LUSCOMBE AIRPLANE CORPORATION  
West Trenton, New Jersey

ENGINEERING BULLETIN NO. 3  
MODEL NO. 8

January 1939

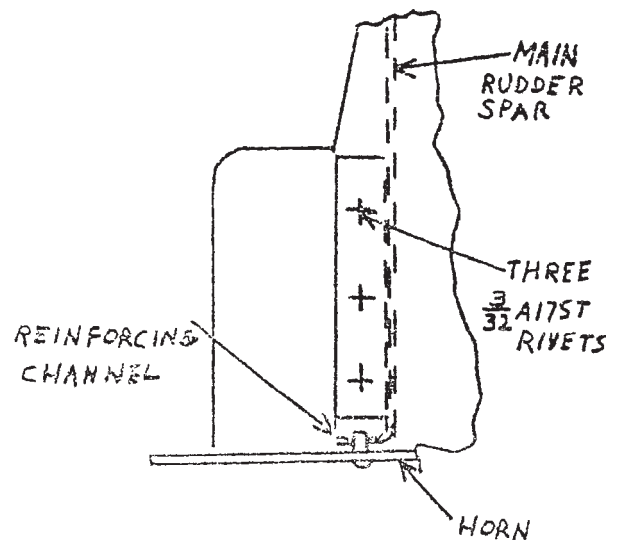
Drill through upper rudder hinge as shown and insert No. 8 steel machine screw and elastic nut. On later serial numbers this hinge bracket is tapered, and it will be necessary to substitute a bracket with straight sides which will be sent to you.

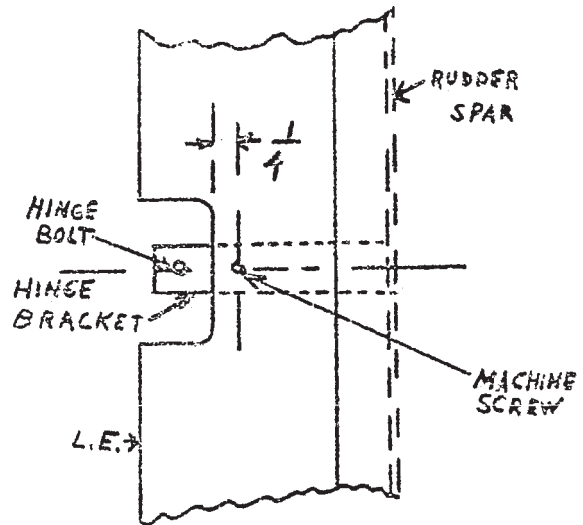
This step is necessary to relieve the lower hinge. Inspect the attachment of lower hinge and if cracks have developed in the spar or rib reinforce with .040 dural or steel channel as shown.
